Model: STR-AV920/AV1020

No. 147

Subject: Service Manual Correction -
IC701 Pin Out

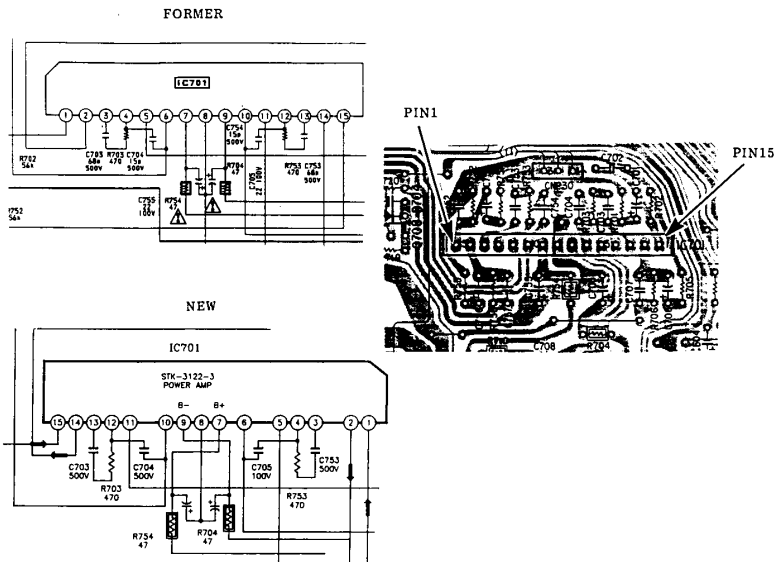
IC701 is shown reversed in the schematic diagram in the service manual. Pins 1 to 15 are listed in the wrong sequence, and B+ and B- are on the wrong inputs when the IC is shown correctly installed.

Solution: Please make the following corrections on page 20 of your service manual, and in the schematic on page 17.
